• NOISE—"BUZZING" COMING FROM ACCELERATOR PEDAL—4.0L OHV VEHICLES • VIBRATION—VIBRATION COMING FROM ACCELERATOR PEDAL—4.0L OHV VEHICLES	Article No. 00-7-5

FORD: 1999-2000 EXPLORER

Figure 1 - Article 00-7-5

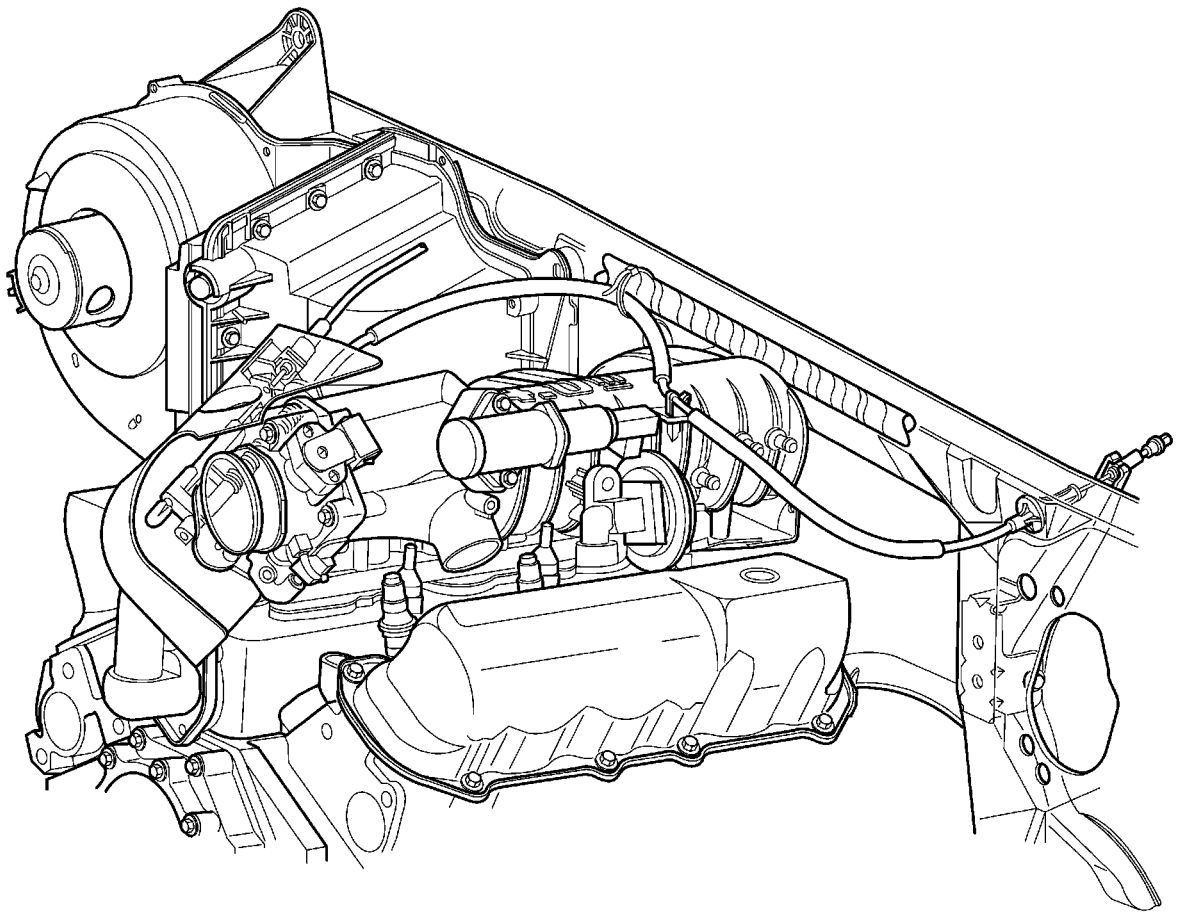
Replace the accelerator cable. This cable is approximately 30 cm (12″) longer and will require a different routing which should reduce the possibility of noise and vibration. Refer to the following Service Procedure for details.

1. Attach new Accelerator Cable (F87Z-9A758-KA) on the same plastic retaining clip used with the original cable.
2. Position the cable so that the clip is between the two (2) foam sleeves.
3. Use a tie wrap to loosely attach the cable to the wiring harness which is in the back of the engine compartment as shown in Figure 1.4 of the Workshop Manual.
4. Verify that the condition is resolved.
